Minerals and Waste Joint Plan

Sustainability Appraisal Addendum Proposed Changes to the Publication Draft

Sustainability Appraisal Report - Addendum of
Proposed Changes to Publication Draft Plan

Prepared by Mouchel Ltd on behalf of
North Yorkshire County Council
City of York Council
North York Moors National Park Authority

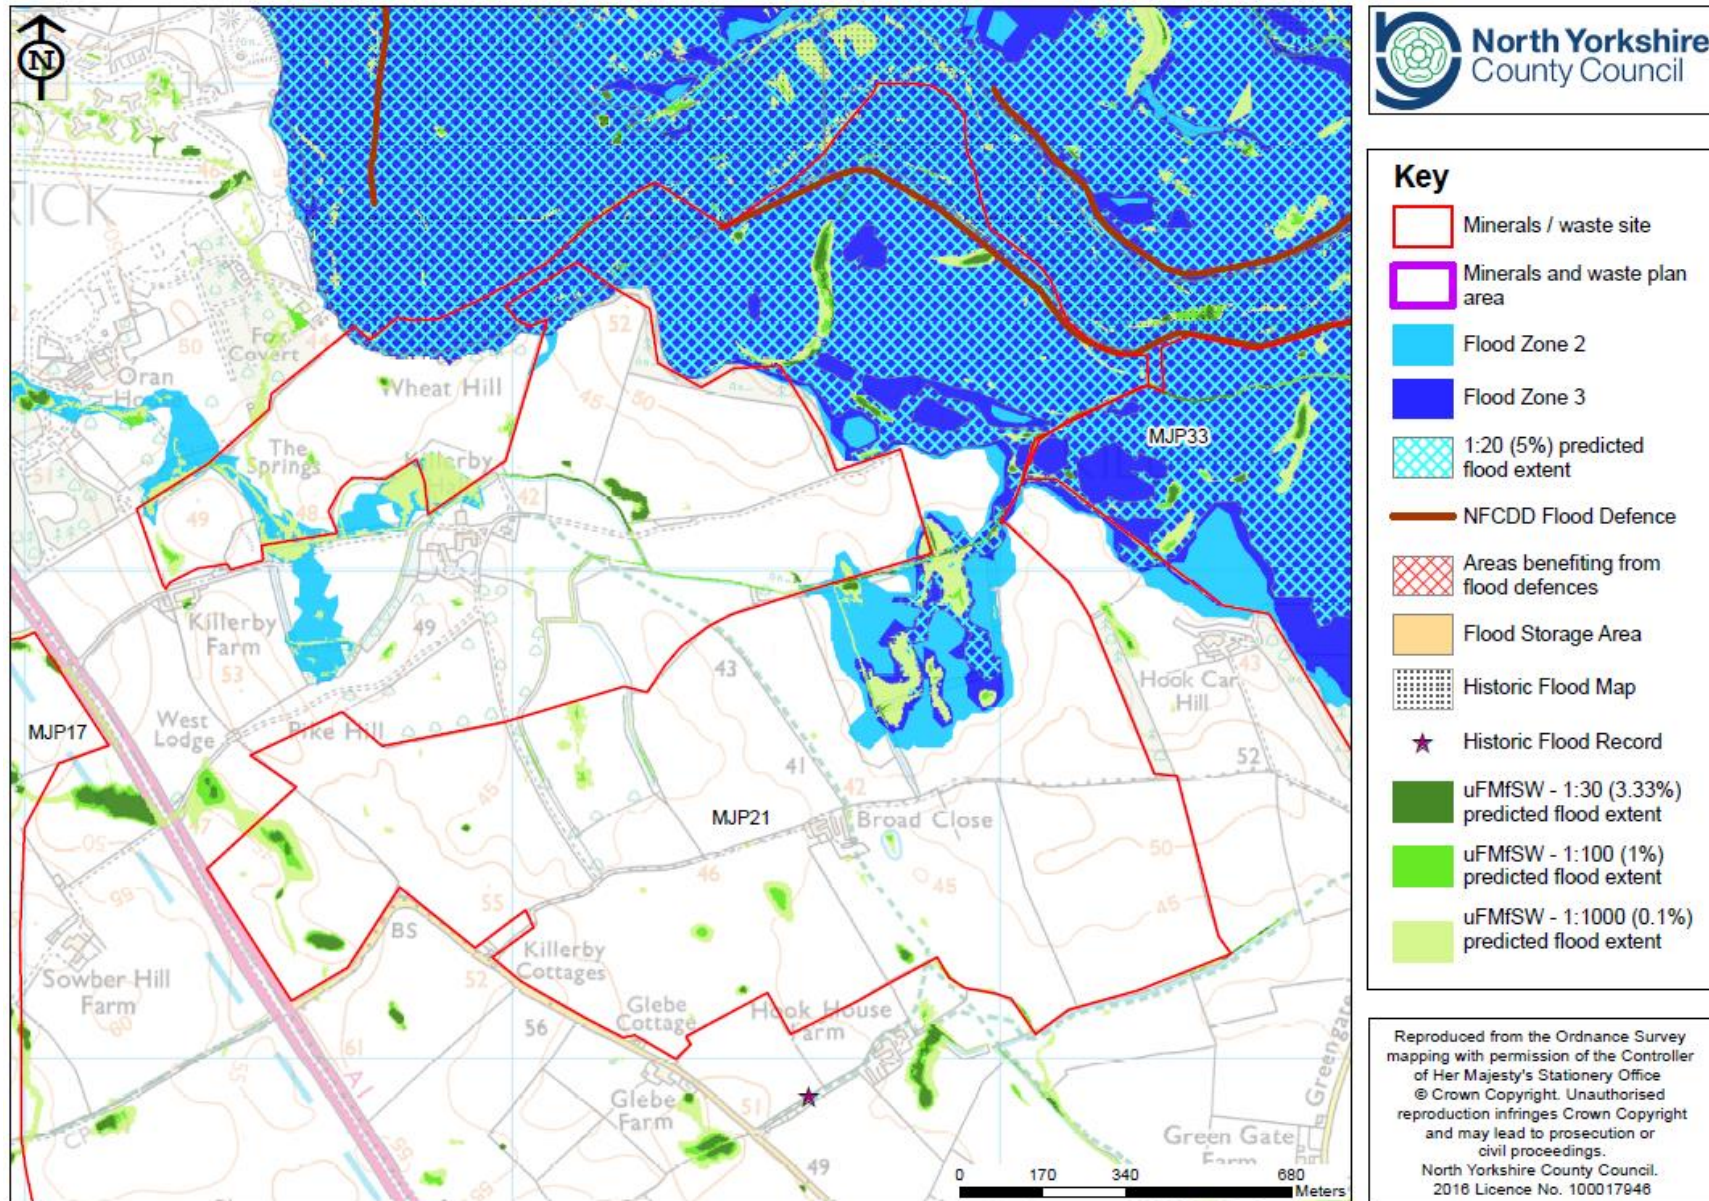
MJP21 Site Plan (PC102)	35	Revise site boundary of allocation MJP21 to exclude land nearest to the Killerby Hall Stable Block listed building. There would be a reduction in the overall area of the site from 213ha to 207ha, with a	To reduce the harm to the setting of the listed building	There would be a proportionate increase of the site area within flood zones 2 and 3 from approximately 35% to 40% of the site, due to the revised boundary resulting in a loss of area

Climate change	<p>As this site would be active beyond 2025, river flooding may increase in significance beyond 2025. This would increase the area of Flood Zone 3 into areas that are shown as Flood Zone 2 and would also increase the extent of Flood Zone 2.</p> <p>Climate change effects on surface water flooding are likely to increase the extents of the areas at risk and also the depth of flooding for each event respectively.</p>
Sequential Test result	Pass. This is water compatible development, however, MJP17 and MJP43 should be considered before this site but this site is preferable to MJP33 from a flood risk point of view.
Exception Test Needed	No. This site is water compatible.
